Economic Commission for Europe**Inland Transport Committee****World Forum for Harmonization of Vehicle Regulations****Working Party on Passive Safety****Fiftieth session**

Regulation No. 14 (Safety-belt anchorages)**Proposal for Supplement 4 to the 07 series of amendments****Submitted by the Chair of the informal group on Child Restraint Systems***

The text reproduced below was prepared by the informal group on Child Restraints Systems (CRS), following discussions at its twenty-seventh meeting to introduce requirements for "i-Size" CRS according to the draft new CRS Regulation (ECE/TRANS/WP.29/GRSP/2011/21). It is based on a document without symbol (GRSP-49-06) distributed during the forty-ninth session of GRSP (see ECE/TRANS/GRSP/49, para. 19). The modifications to the text of the Regulation are bold for new or strikethrough for deleted characters.

Figure 1
3D view of the support leg foot assessment volume

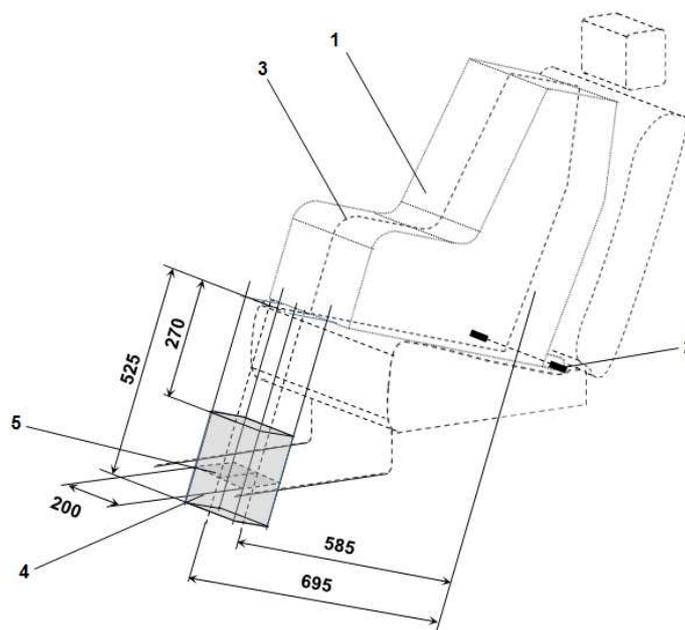
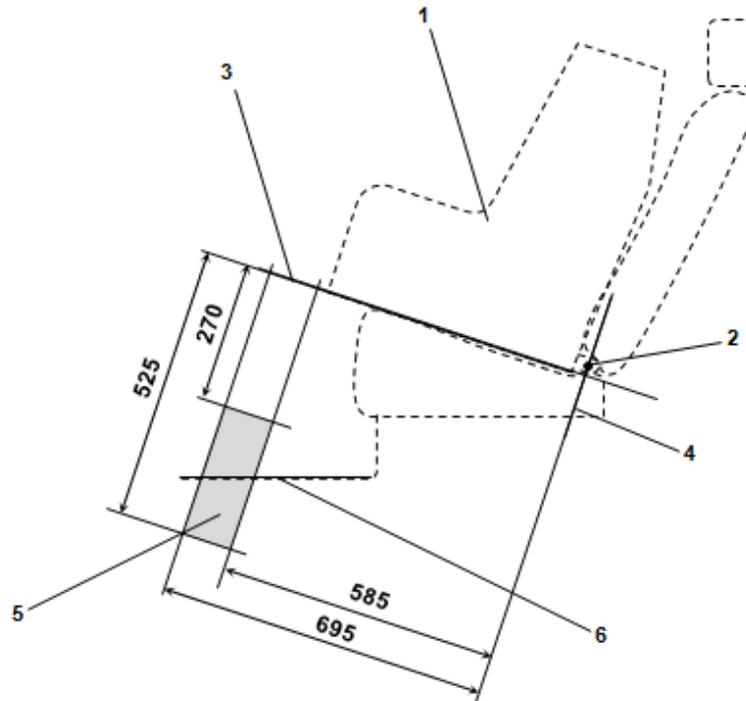
In addition to the requirements defined in 5.2.3. and 5.2.4. it shall be verified that the upper surface of the vehicle floor (incl. trim, carpet, foam, etc.) intersects with both of the limiting surfaces in the x- and y-directions of the support leg foot assessment volume, as shown in figure 1 and 2 of Annex 10 of this Regulation.

The support leg foot assessment volume is characterized as follows (see also annex 10, figure 1 and 2 of this Regulation):

- (a) In width by the two planes parallel to and 100 mm apart from the median longitudinal plane of the child restraint fixture installed in the respective seating position; and
- (b) In length by the two planes perpendicular to the plane given by the child restraint fixture bottom surface and perpendicular to the median longitudinal plane of the child restraint fixture, 585mm and 695 mm apart from the plane passing through the centerlines of the ISOFIX lower anchorages and being perpendicular to the CRF bottom surface; and
- (c) In height by two planes which are parallel to and 270 mm and 525 mm below the child restraint bottom surface.

Example for a modified Static force application device with support leg test probe (SFAD_{SL}) showing the required adjustment range and dimensions of the support leg foot

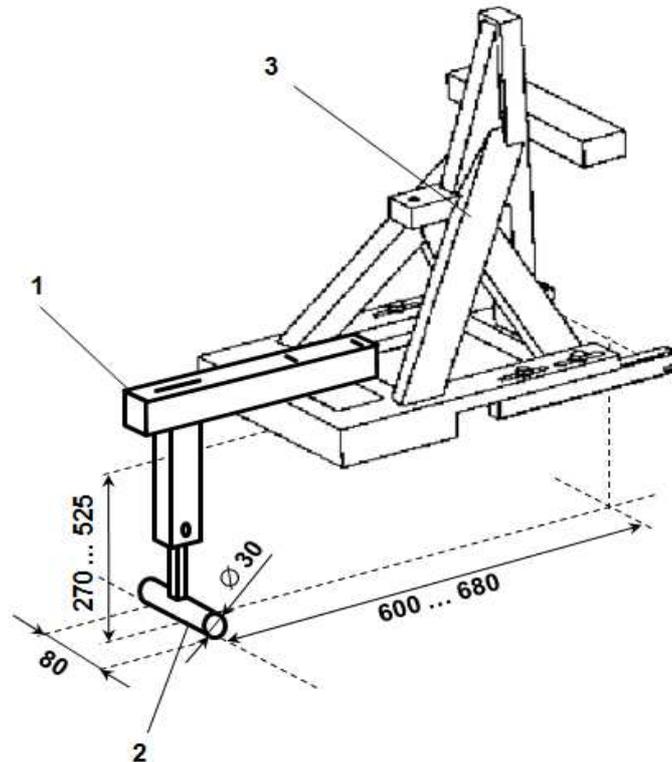
In addition to the tests specified in paragraphs 6.6.4.3. and 6.6.4.4., a test with a modified static force application device, which consists of a SFAD and includes a support leg test probe as defined in figure 3 of annex 10, shall be performed. The support leg test device shall be adjusted in length and width to assess the vehicle floor contact surface, as defined in paragraph 5.2.5.2. (see also figures 1 and 2 of Annex 10 of this Regulation). The height of the support leg test device shall be adjusted in a way that the foot of the support leg test device is in contact with the upper surface of the vehicle floor. In case of incremental height adjustment, the first notch where the foot rests stable on the floor shall be chosen; in case of a non-incremental/continuous adjustment of the support leg test device height, the pitch angle of the SFAD shall be increased by 1.5 +/- 0.5 degrees due to the height adjustment of the support leg test device.

The horizontal excursion (after pre-load) of point X of the SFAD during application of the 8 kN ± 0.25 kN force shall be limited to 125 mm and permanent deformation including partial rupture or breakage of any ISOFIX low anchorage and the vehicle floor contact surface, or surrounding area shall not constitute failure if the required force is sustained for the specified time."

Figure 4
Symbol used to identify an i-Size seating position

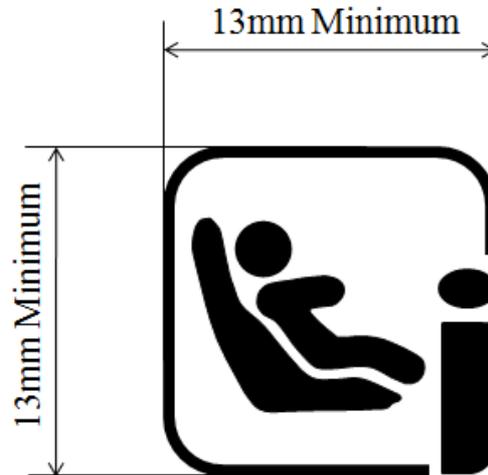
The minimum marking shall be the symbol of Annex 10, figure 4 consisting of a square with a minimum size of 13 mm and containing a pictogram and meeting the following conditions:

- (a) **the pictogram shall contrast with the background of the square;**
- (b) **the pictogram shall be located close to each bar of the system.**
